OUTAGAMIE COUNTY YOUTH AND FAMILY SERVICES

LOWER LEVEL REMODEL

COMMUNICATIONS PLAN

E103

COMMUNICATIONS PLAN

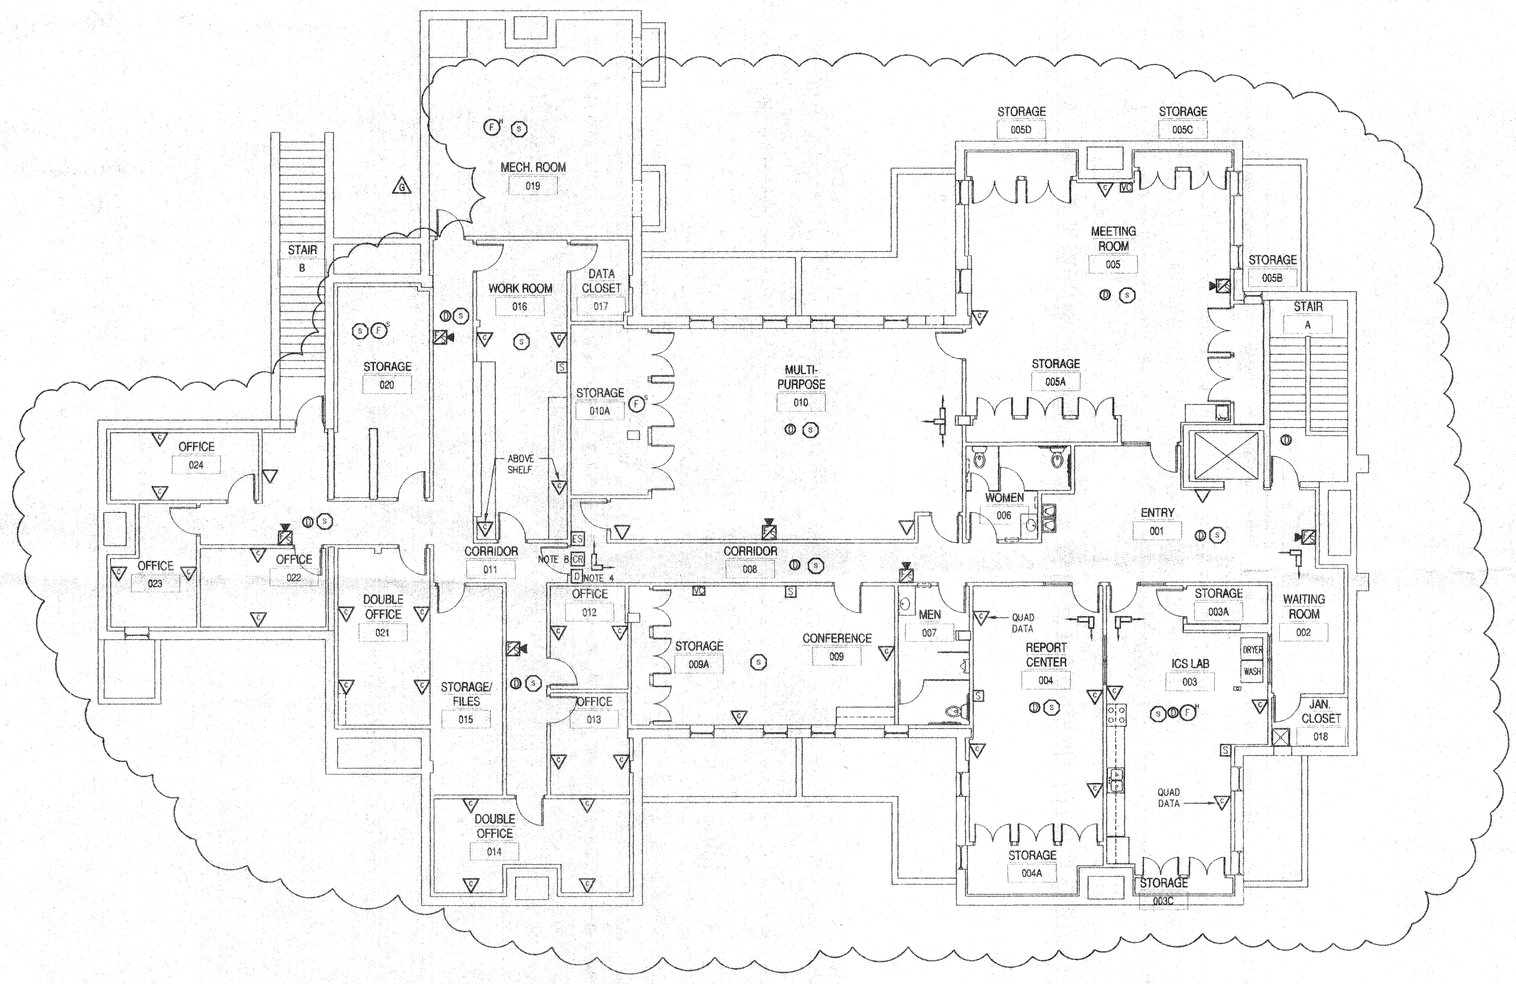
8. G CONTRACTOR TO INSTALL PULL STATION AT FIRE RISER.
